SUNDRY NOTICES AND REPORTS ON WELLS

8. Well Name and No. Central Corbin #209 Queen Unit

OXY USA Inc. - Proposed  
Central Corbin Queen Unit #209  
API No. 30-025-29777

**Central Corbin Queen Unit #209  
30-025-29777  
OXY USA Inc.  
October 26, 2009  
Conditions of Approval**

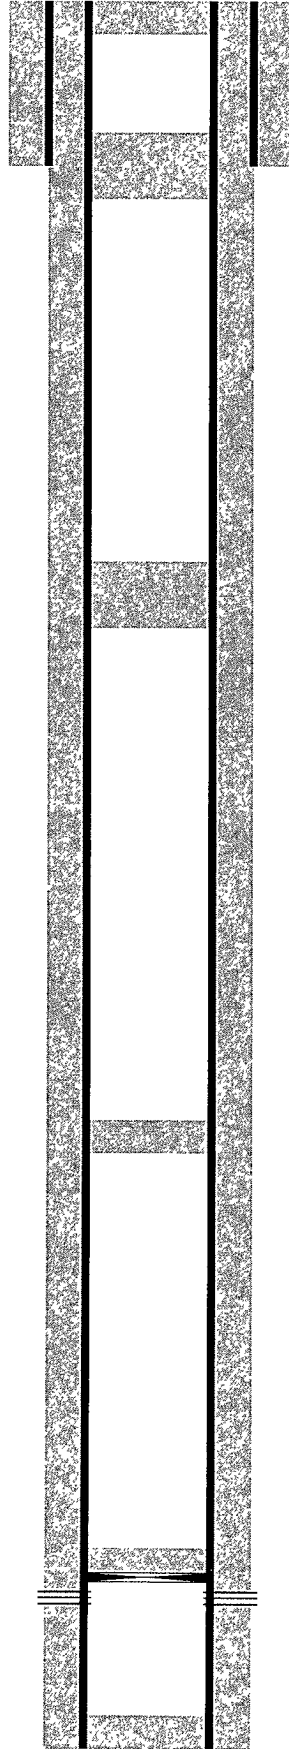
- 1. OK**
- 2. OK**
- 3. Move this plug to 1,632' to be 50' below the top of salt.**
- 4. OK**
- 5. OK**
- 6. It is recommended that you combine plugs 4 & 5, this will save a tag.**
